Memo

Re: Consultation on an Application

Planning Application Ref: PL/26/0868

Proposal: Erection of new detached garage

Google StreetView – 16 Jefferson Close (red arrow); approximate location of proposed garage (blue arrow)

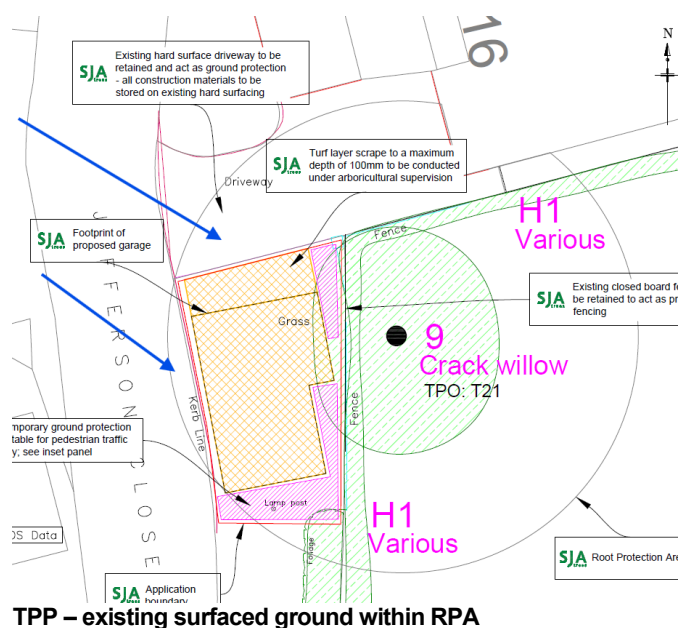
The site of 16 Jefferson Close is subject to Tree Preservation Order 73/03. The site is also situated along a Green Link and within an area of recorded protected and priority species. The location of the proposed garage is along a soft, grass verge along the entrance of Jefferson Close, contributing to its street scene.

Section Drawing – existing ground level not clear; excavation shown more than 100mm

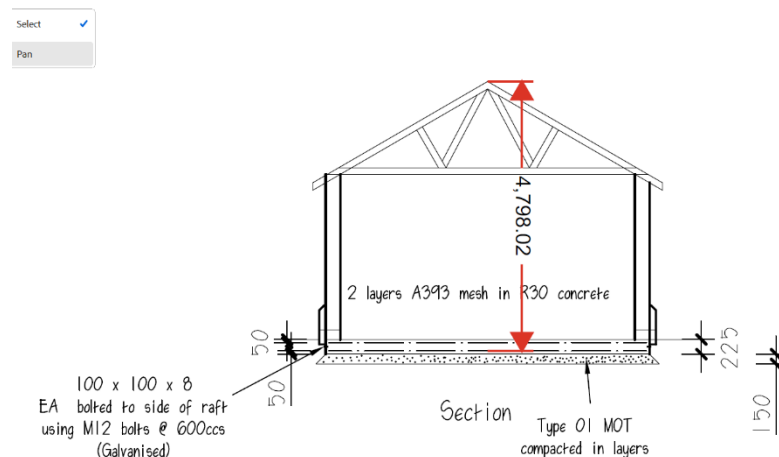
Section 6.2.2. states *'The foundation of the proposed garage will be of a slab design which will be situated on top of the existing ground level. Consequently, ground preparation will consist of the removal of the turf layer and levelling of the minor change in ground level from the fence at the northern extent to the kerb to the south, resulting in excavation no deeper than 100mm. This maximum depth will be isolated to the northern extent of the garage, due to the minor level difference. The extent of excavation gradually reduces in extent from that point down to towards the road, with ultimately only the removal of the turf layer being required.'* As mentioned above, we do not consider this acceptable as the BS5837 advises that ground levelling should not occur within an RPA beyond the turf layer. The Proposed Section Plan below, doesn't seem to show only 100mm of excavation - the plan appears to show 225mm of excavation for the concrete base, and a further 150mm for the Type 01 MOT. Whilst I appreciate there is a *'very minor upward slope (approximately 100mm) from the kerb to the eastern boundary'*, the elevation shows further excavation than that detailed within the AIR. The existing ground level is not labelled in the elevations, which makes this particularly unclear to understand. It would also be useful to include several section diagrams to demonstrate where the existing and proposed ground levels are compared to the garage.

Section 6.2.3. states *'As there are underground services in the area, piles will not be utilised, further limiting the impact on the RPA. Additionally, over dig during construction will be negligible as there is no need to set the foundation into the ground, which might otherwise necessitate additional workspace, the turf removal and ground levelling will be contained within the area of the foundation.'* I'm unclear what is meant by this when if the foundations were built on piles, this would limit excavation to the piles - the foundations are shown to be set into the ground in the elevation drawings.

Section 6.2.5. states '*Furthermore, as the proposed building is relatively narrow, water will still be able to penetrate to the ground underneath the footprint from the edges; therefore, this area will remain a viable rooting environment, despite the new foundation.*' – no gap between the ground and the base is shown, with soil compaction expected so it is not agreed this will remain as a viable rooting environment. The existing soft ground is proposed to be replaced with compacted Type 01 MOT base and concrete, which will compact the soil and limit water permeability and gaseous exchange.
